ADDENDUM NO. 2
HOLBROOK MUNICIPAL AIRPORT
MARCH 26, 2024

RE: Schedule I – Reconstruct Apron
Schedule II (Non-AIP) – Reconstruct Apron Hangar Connections
AIP No. 3-04-0020-0xx-2024 | ACI No. 22965

Sheet: 2.1

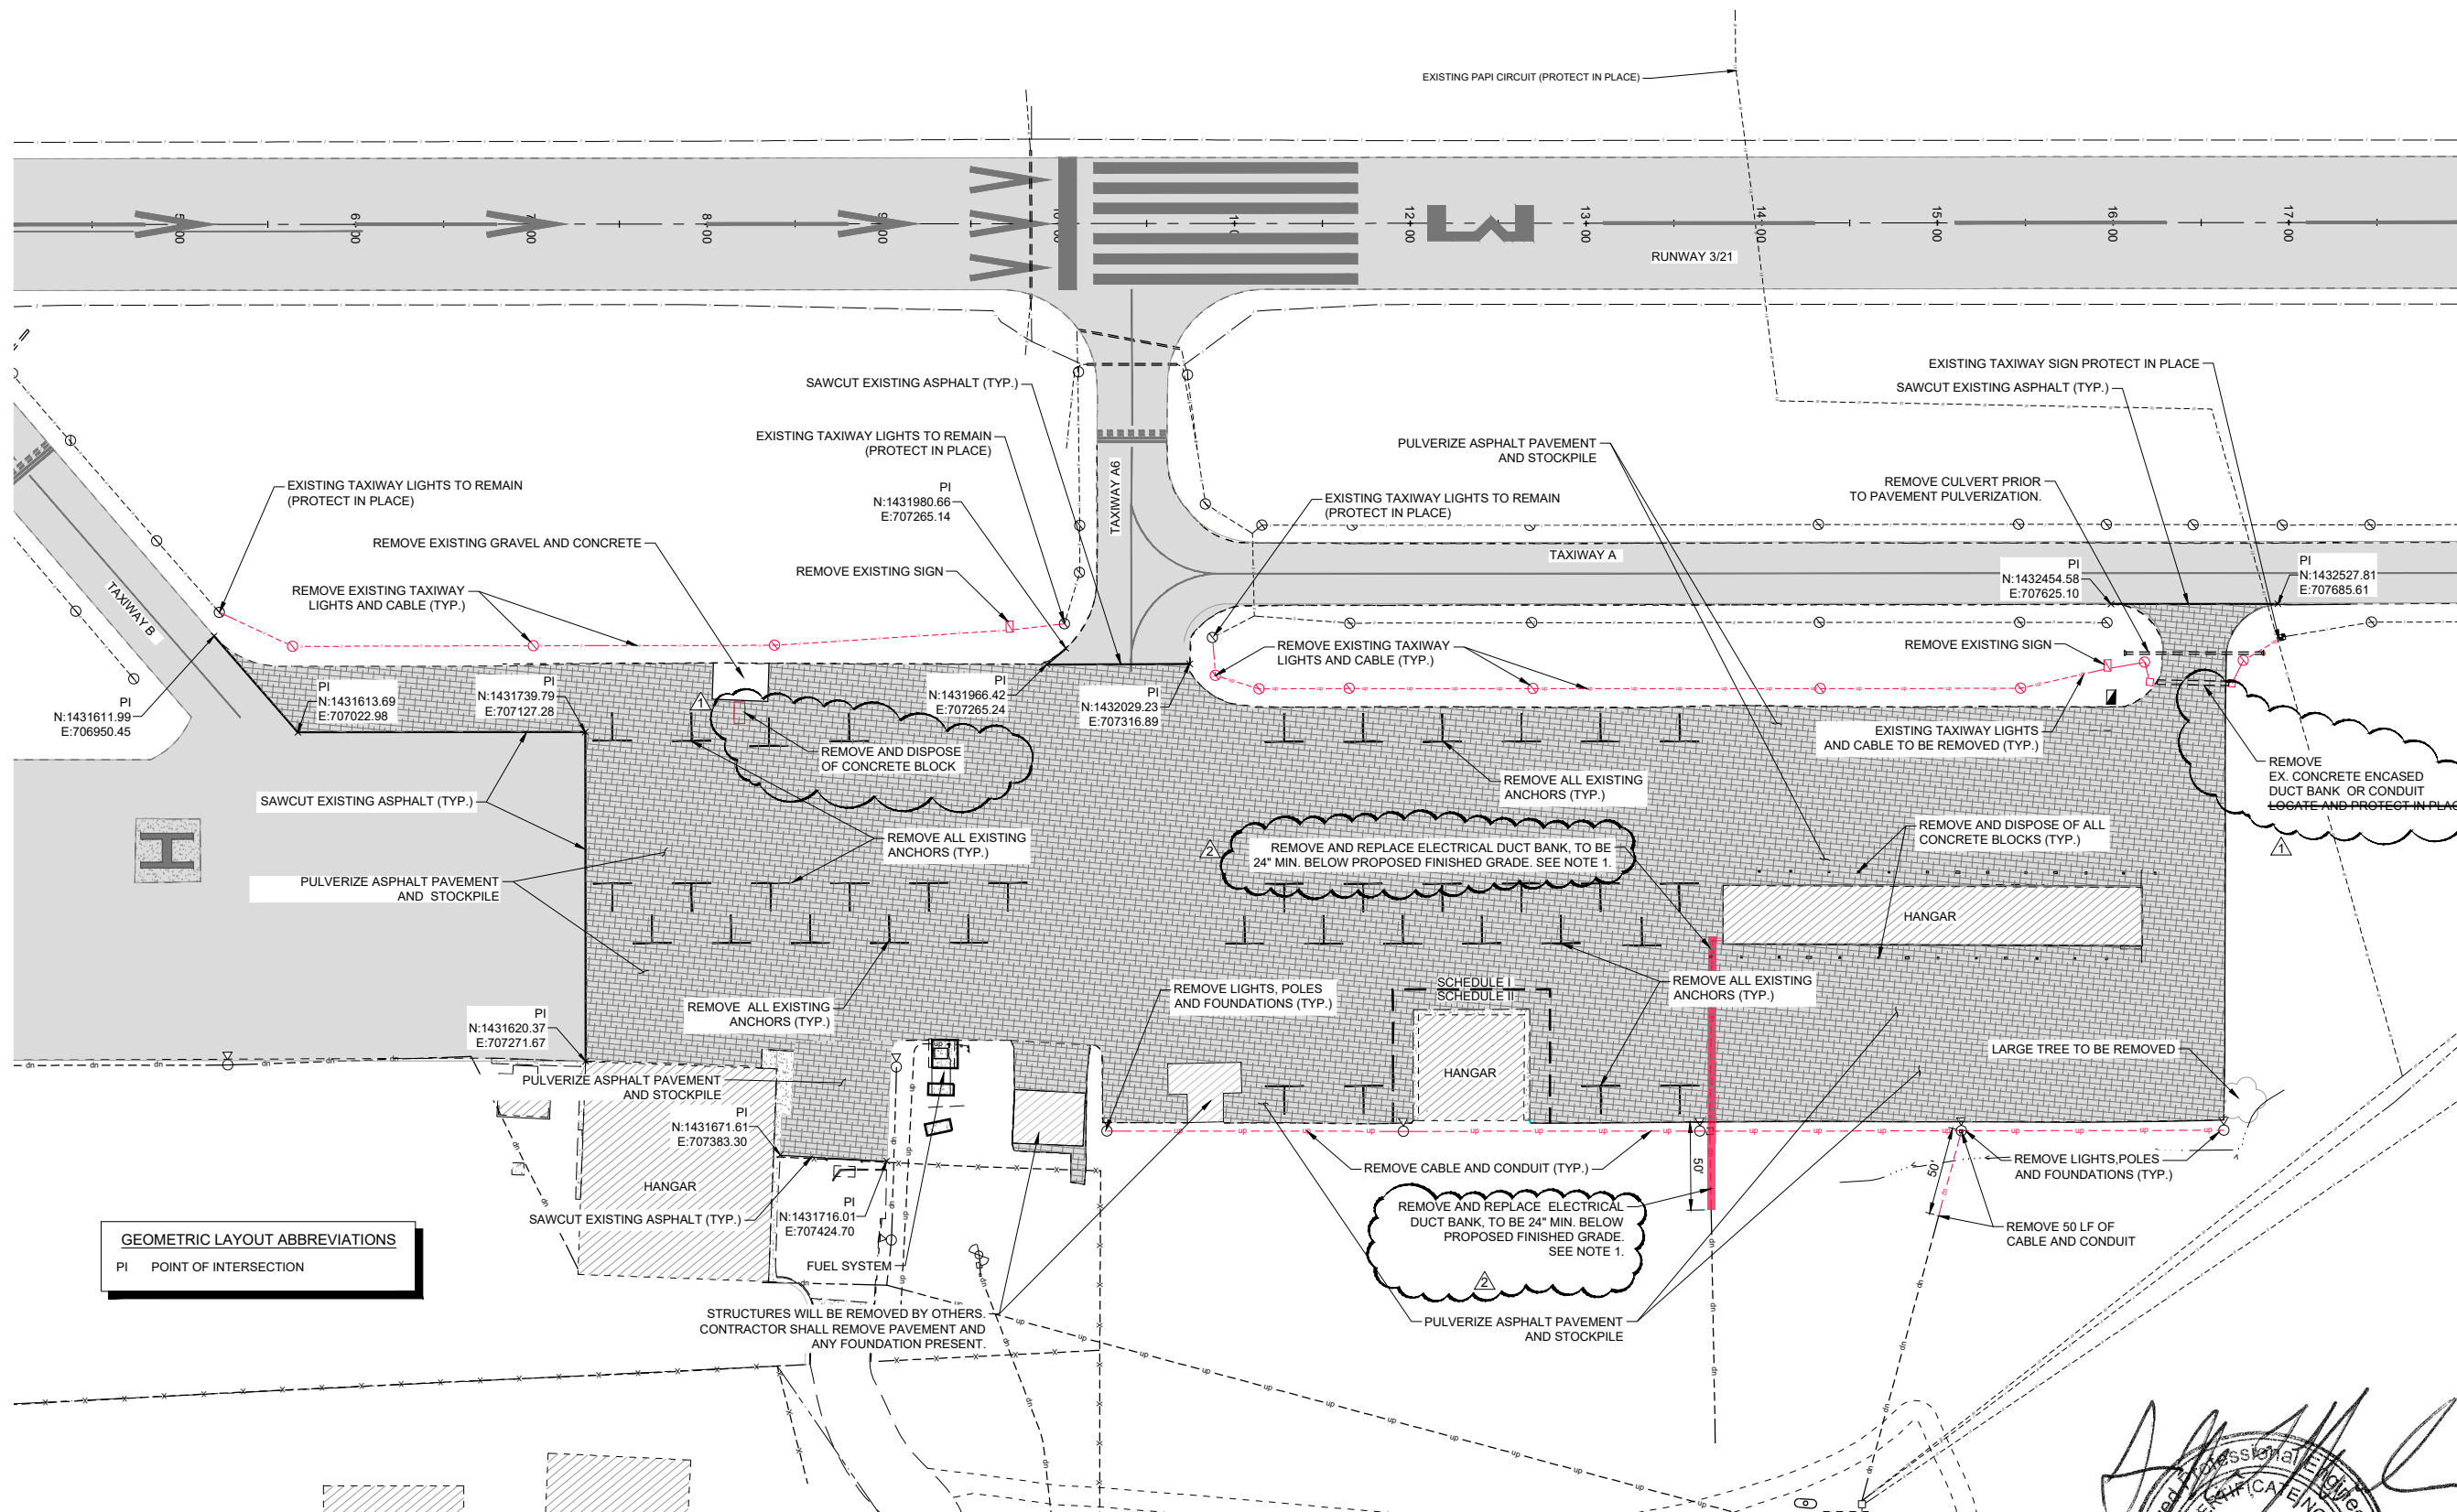
- A. **Plan Sheet 2.1.** Additional clarification has been provided for the removal and replacement of the existing hangar duct bank. The revised Sheet 2.1 is attached.
- B. **Plan Sheet 3.1.** The asphalt edge callout located near the bottom right of the sheet has been revised to callout Thickened Edge, Detail 5/4.1. The only proposed location that the non-thickened asphalt edge is present is on Sheet 3.2 on the upper right side of the connector taxiway between the apron and Taxiway A. The revised Sheet 3.1 is attached.

- Q.) Is any additional information available pertaining to the existing electrical duct bank called out to be removed and replaced on Sheet 2.1?
- A.) The number of conduits and cables or condition of the existing underground electrical service to the T-hangars is unknown. There is a concrete junction box off the edge of pavement on the east edge of the apron that appears to be in line with the service, but the components within are unknown. The intent of the P-101f Remove and Replace Electrical Duct Bank is to remove the existing service connection only if service is located within 24 inches of the proposed surface. If the service is found deeper than 24 inches, the existing system will be protected in place. If the service is within 24 inches, then the existing system will be replaced with a new concrete encased 2 inch PCV conduit with new splice bases off the edge of pavement and at the existing 2 inch drop-down service on the hangar. Electrical cable matching the existing removed electrical cables shall be installed in the new conduit and connected to the existing hangar circuits.

GENERAL NOTES
 1. IF THE EXISTING DUCT BANK IS FOUND TO BE DEEPER THAN 24 INCHES FROM THE PROPOSED PAVEMENT SURFACE, THE EXISTING DUCT BANK SHALL REMAIN IN PLACE AND PROTECTED DURING CONSTRUCTION. IF IT IS FOUND WITHIN 24 INCHES OF THE PROPOSED SURFACE, THE DUCT EXISTING DUCT BANK AND THE CONCRETE JUNCTION BOX OFF THE PAVEMENT EDGE SHALL BE REMOVED. A NEW CONCRETE ENCASED SINGLE 2 INCH PVC DUCT BANK SHALL BE INSTALLED AT A DEPTH OF 24 INCHES FROM THE PROPOSED SURFACE. TWO NEW SPLICE BASES (DETAIL 35.2) SHALL BE INSTALLED OFF THE PAVEMENT EDGE AND AT THE HANGAR. THE HANGAR SPLICE BASE SHALL BE CONNECTED TO THE EXISTING 2 INCH STEEL RISER ON THE HANGAR WALL. NEW ELECTRICAL CABLE SHALL BE INSTALLED TO RECONNECT THE HANGAR ELECTRICAL SERVICE.
